SERVICE CHANGES

1. Change on Washer.

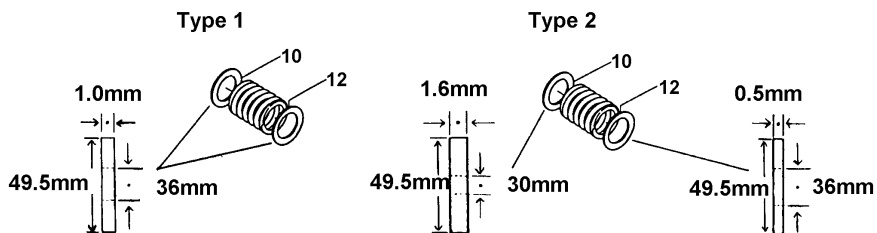
Item No.	Description	Type 1	Type 2
10	Flat Washer	253182-9	253764-7
12	Flat Washer	253182-9	253765-5
	Serial No.	up to 6809E	6810E & Higher

2. Change on Internal Gear.

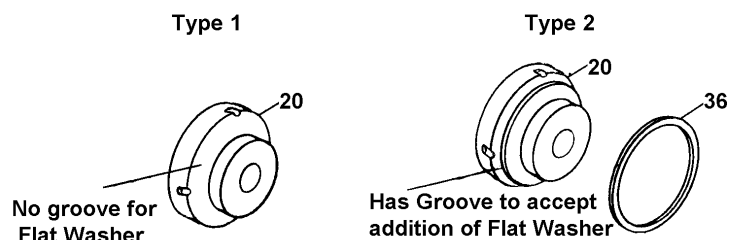
Item No.	Description	Type 1	Type 2
20	Internal Gear	221242-5 (Discontinued)	221242-5A
36	Flat Washer 65	—	253774-4 (Added)
	Serial No.	up to 10816E	10817E & Higher

3. Change on Anvil.

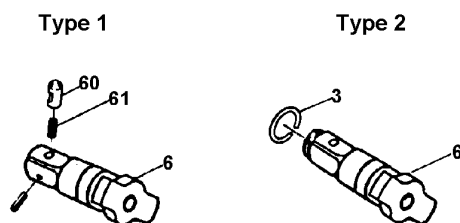
Item No.	Description	Type 1	Type 2
3	Ring Spring 16	—	231920-9A
6	Anvil Assembly	325317-3 (Discontinued)	325586-6 (With Item 3)
60	Pin 7	325365-2 (No longer available)	—
61	Compression Spring 2	231157-8	—
62	Pin 2	256710-9 (No longer available)	—
	Serial No.	up to 10254E	10255E & Higher

4. Change on Motor Hsg., Handle Cover, Rear Cover, Cord Guard etc.

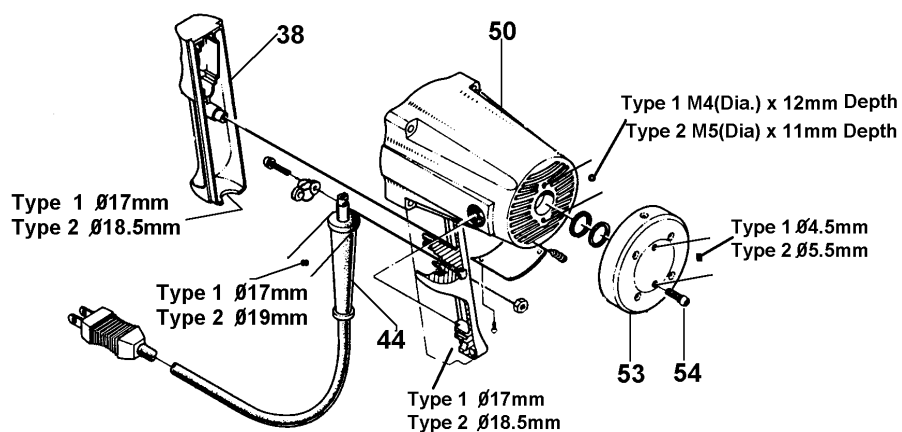
Item No.	Description	Type 1	Type 2
38	Handle Cover	411213-2	414959-9
44	Cord Guard	682502-4	682503-2
50	Motor Hsg. Com.	156086-3 (No longer available)	159414-1
53	Rear Cover	284018-1 (No longer available)	284065-2(Hardened)
54	P.H. Screw	911126-2 (M4x16)	922221-3(M5x16)
	Serial No.	~ 61130E	61131E ~

Above parts are completely interchangeable as a set.
Type 2 Handle Cover + Type 2 Cord Guard can replace Type 1 Handle Cover.
